PROJECT: WSISD - New Maintenance and Operations Warehouse 24-103.00      DATE: 5/30/2025

SUBJECT: 24-103.00 - New Maintenance and Operations Warehouse - Addendum 01      TRANSMITTAL ID: 00006

ADDENDU NO. 1 TO THE DRAWING  
FOR  
**NEW MAINTENANCE AND OPERATIONS WAREHOUSE**  
**WHITE SETTLEMENT ISD**  
**WHITE SETTLEMENT, TEXAS**

1 OVERALL SITE PLAN  
SCALE: 1" = 30'-0"

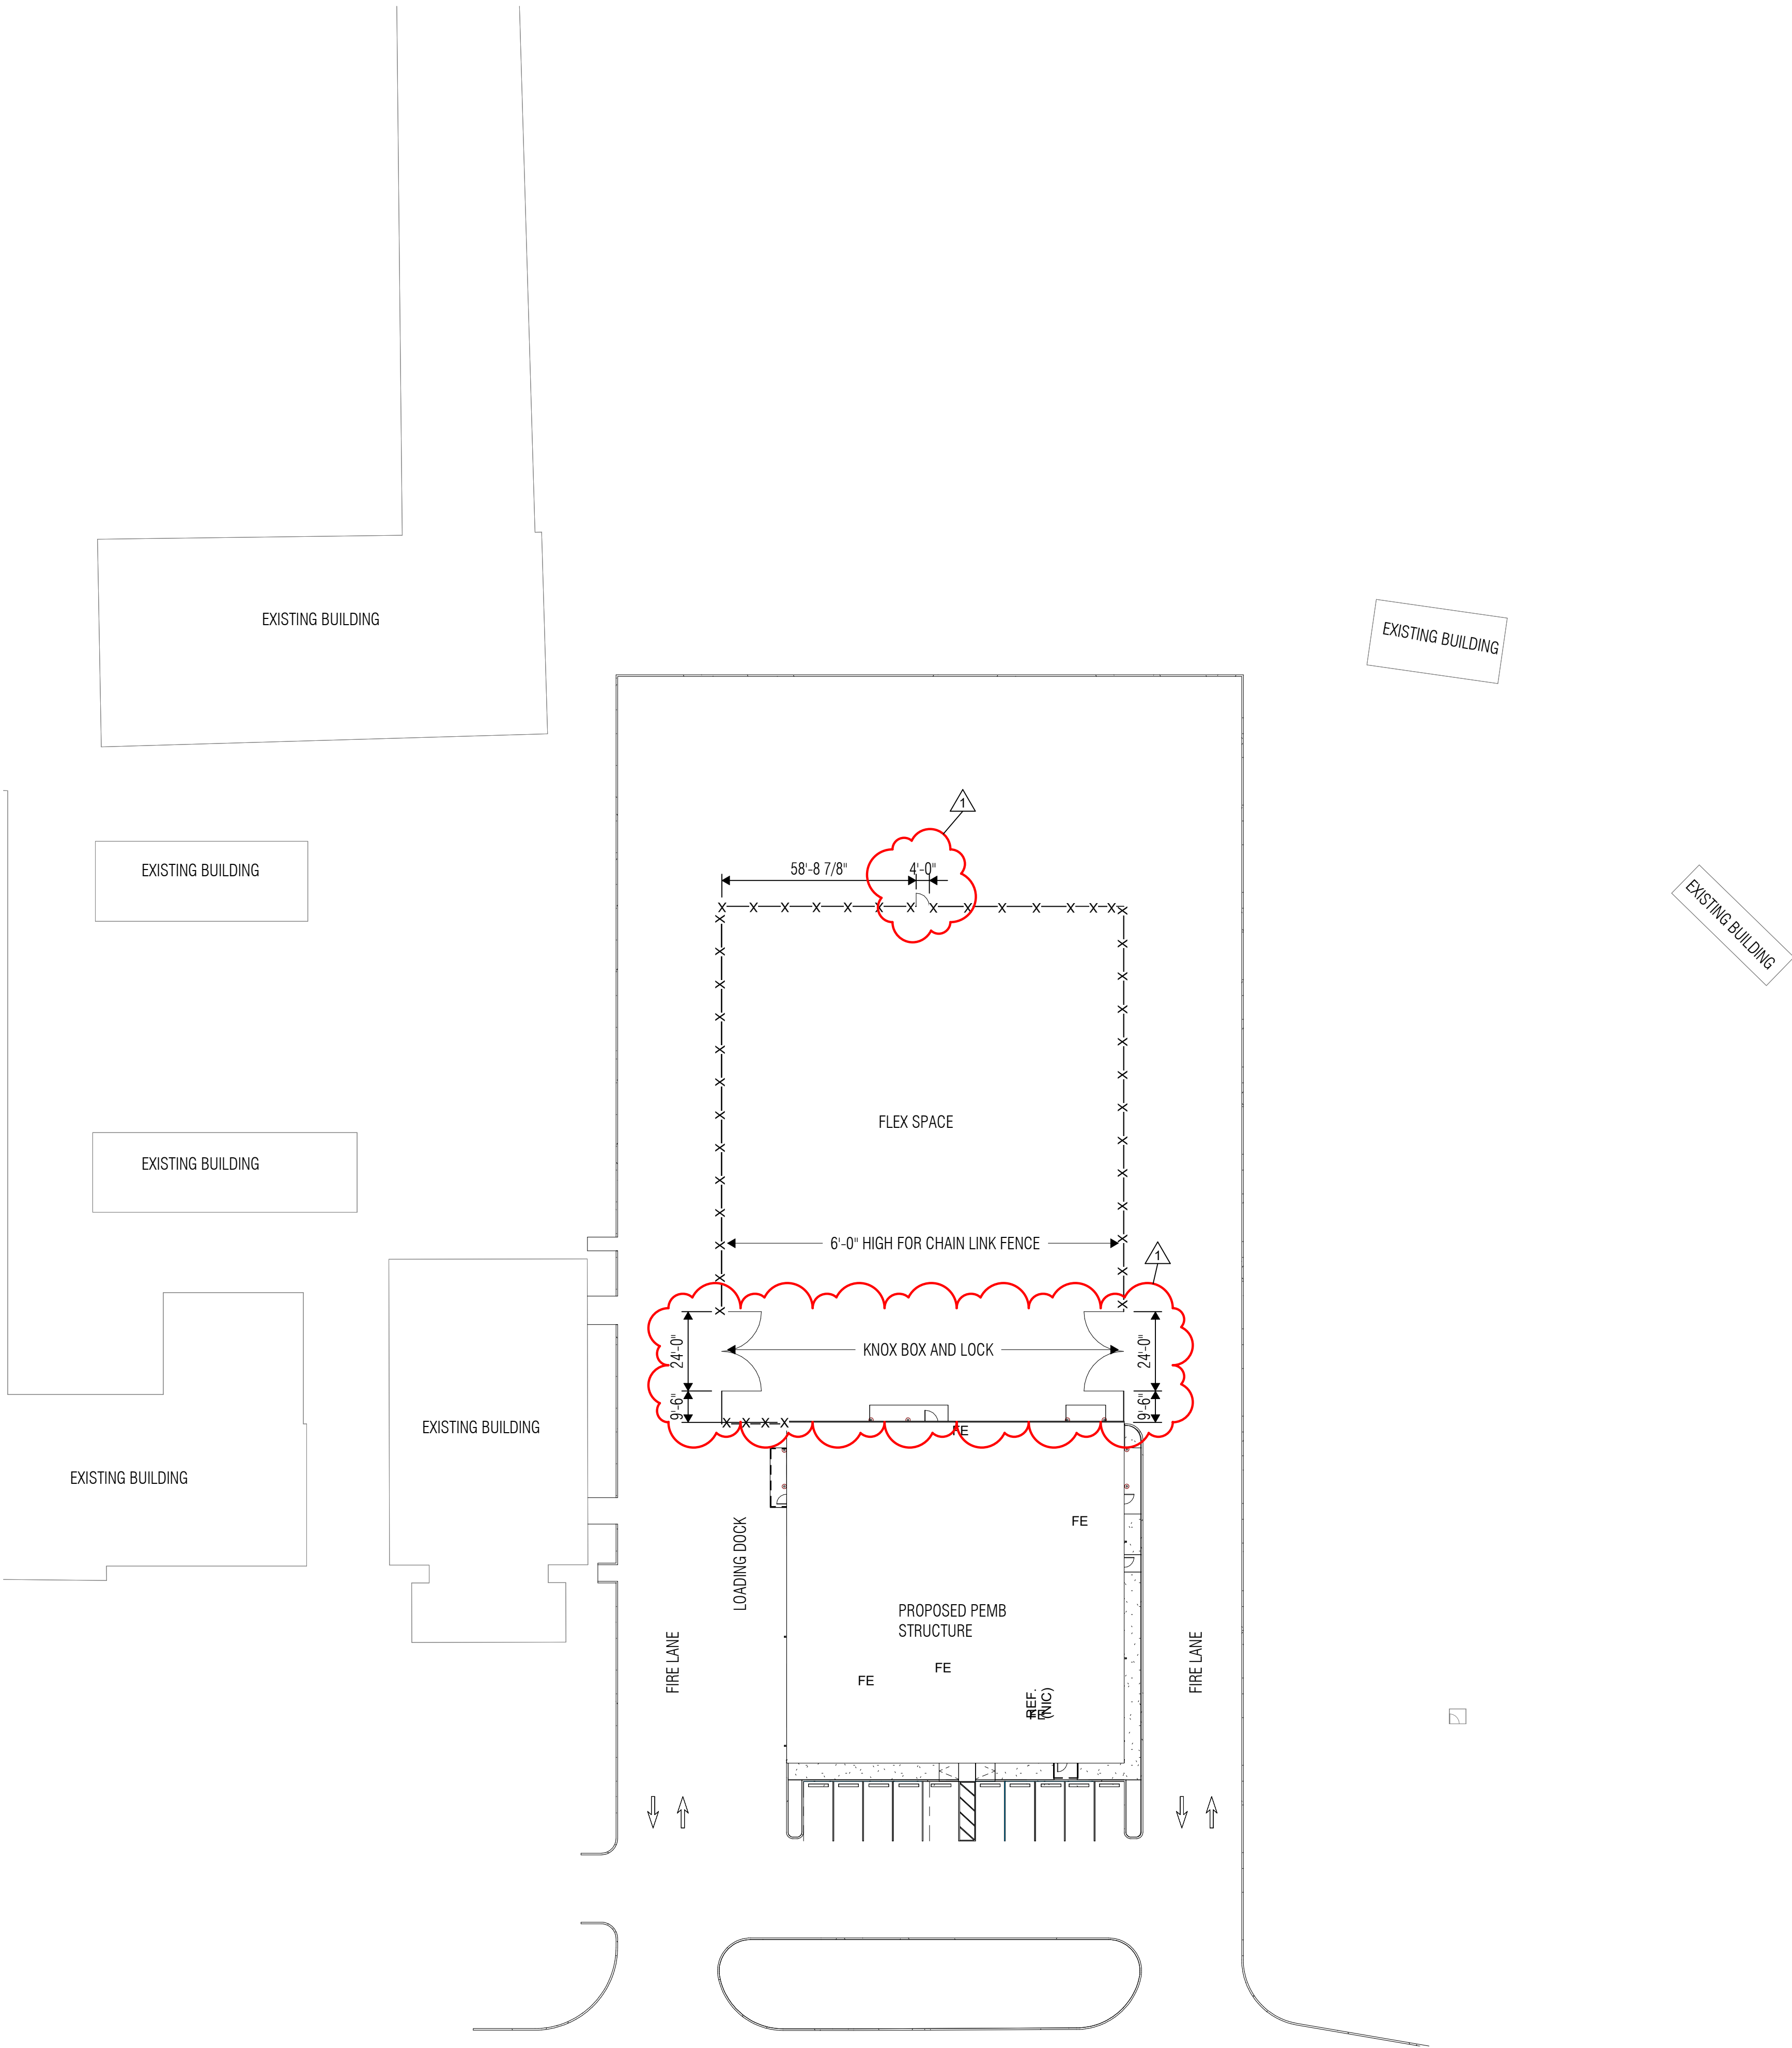
**1.2 SHEET A1.11 OVERALL SITE PLAN – FLEX AREA**

- A. 2 quantity set of 12'-0" added to North and South side of the 6'-0" high chain link fence.
- B. Knox Box and lock to be added to the 2 quantity 12'-0" gate for Fire Official access.
- C. 4'-0" gate added to the East side of the chain link fence.

1 FLOOR PLAN  
SCALE: 1/8" = 1'-0"

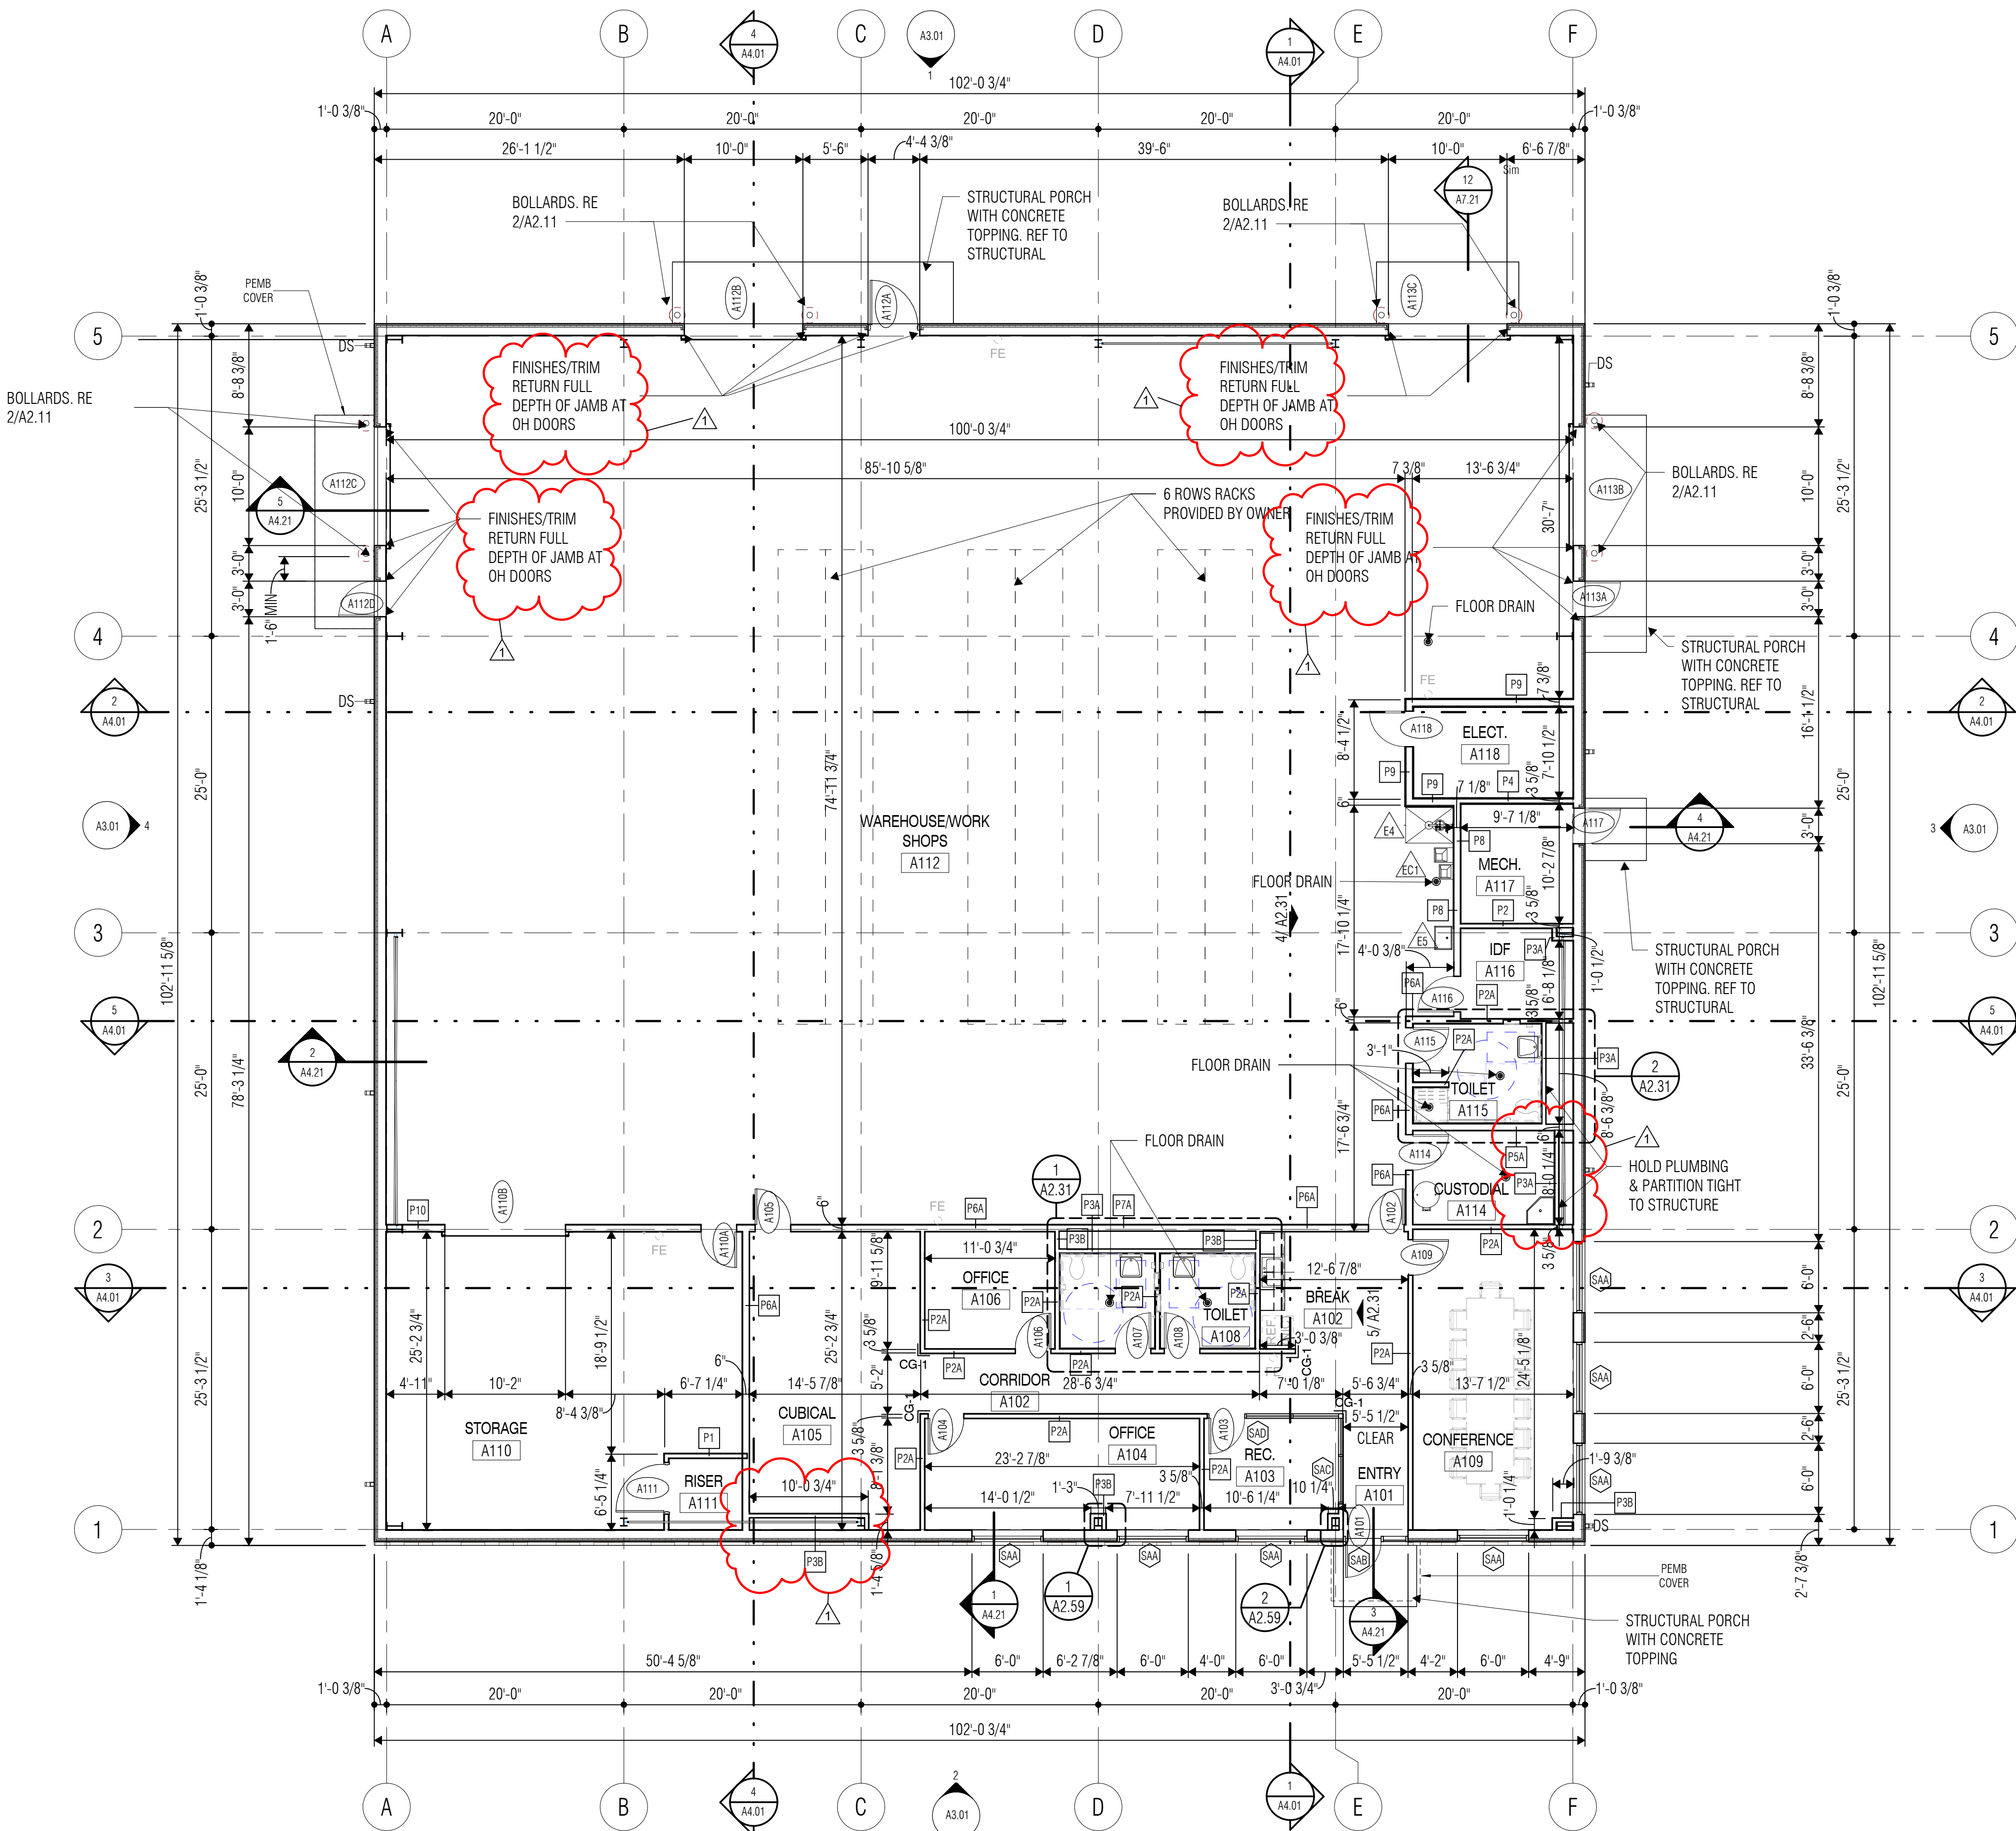
**1.3 SHEET A2.11 FLOOR PLAN**

- A. Note stating "Finish/trim return full depth of jam at OH door" added to the floor plan.
- B. Fur out wall, wall partition 3A, added in the Custodial room for mop sink.
- C. Fur out wall, wall partition P3B, added in the Cubical room to cover x bracing.
- D. On Floor Plan Notes, notes referencing CMU have been removed as it does not apply to project.
